MONTICELLO NUCLEAR GENERATING STATION

AMENDMENT TO PROVISIONAL OPERATING LICENSE

Amendment No. 29
License No. DPR-22

ATTACHMENT TO LICENSE AMENDMENT NO.29

SAMPLING LOCATIONS
MONTICELLO NUCLEAR GENERATING PLANT
RADIATION ENVIRONMENTAL MONITORING PROGRAM

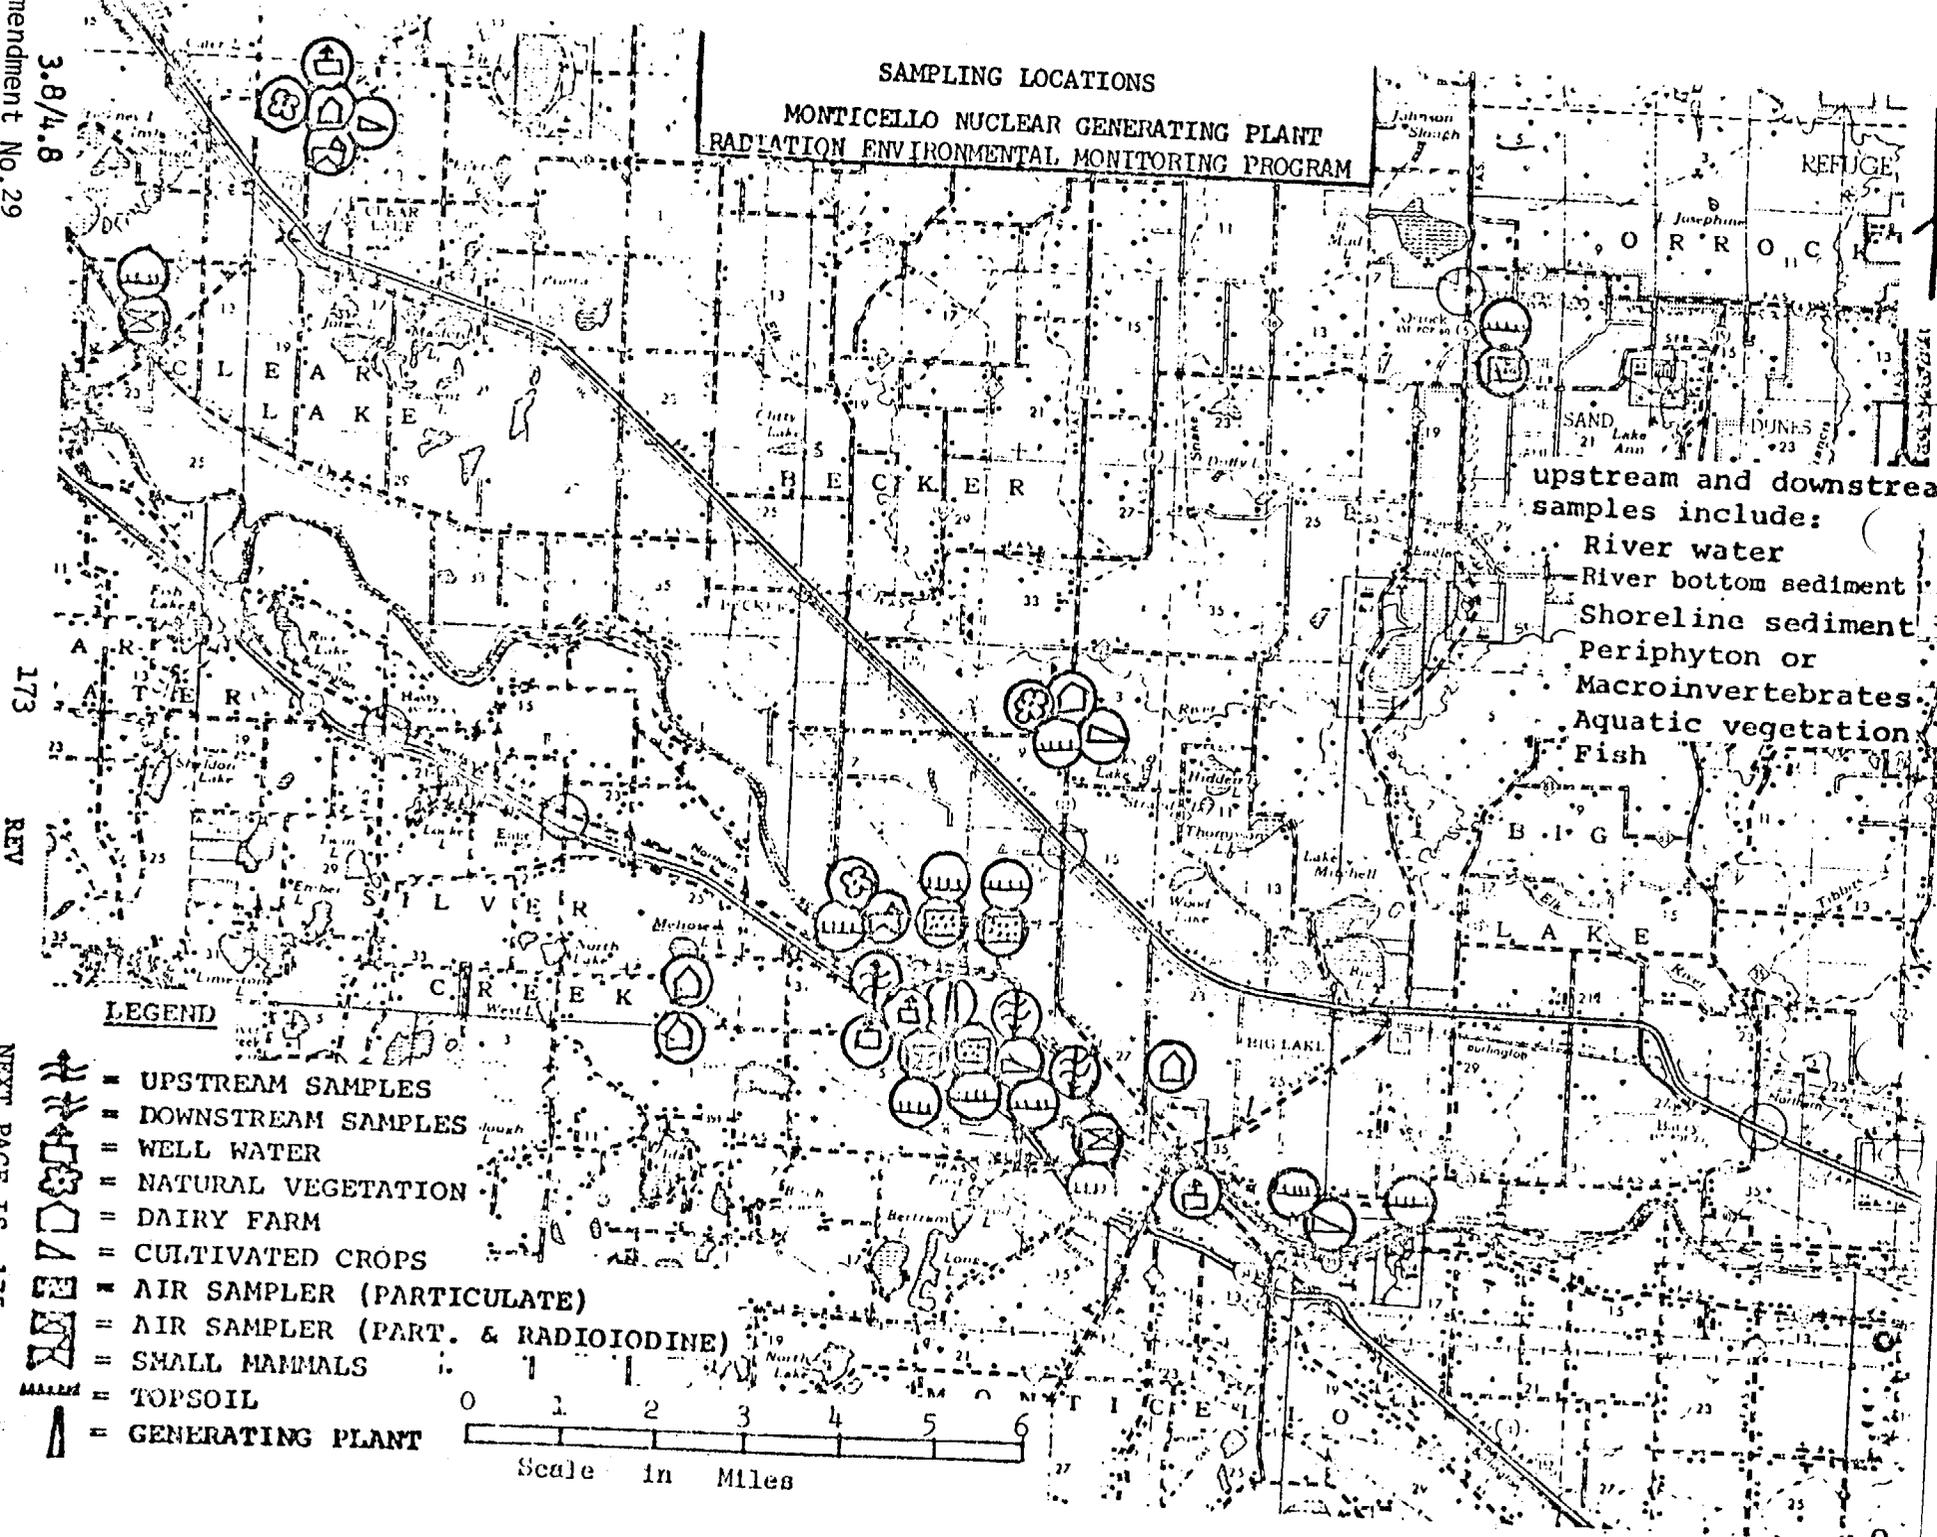
We have evaluated the potential for environmental impact of plant operation in accordance with the enclosed amendment. The amendment applies to the clam sampling program. The clam sampling program is being deleted because in eight years of sampling, extensive searching for clams has met with little success. Monticello Nuclear Generating Plant's radiation monitoring program will be adequate to protect the health and safety of the general public even though the clam sampling program is deleted. We have determined that the amendment does not authorize a change in effluent types or total amounts nor an increase in power level, and will not result in any significant environmental impact. Having made this determination, we have further concluded that the amendment involves an action which is insignificant from the standpoint of environmental impact and pursuant to 10 CFR § 51.5(d)(4) that an environmental statement, negative declaration or environmental impact appraisal need not be prepared in connection with the issuance of this amendment.

Replace the existing pages of the Technical Specifications listed below with the attached revised pages bearing the same numbers, except as otherwise noted. Changed areas on these pages are shown by marginal lines:

The amendment permits elimination of clam sampling from the Radiation Environmental Monitoring Program.
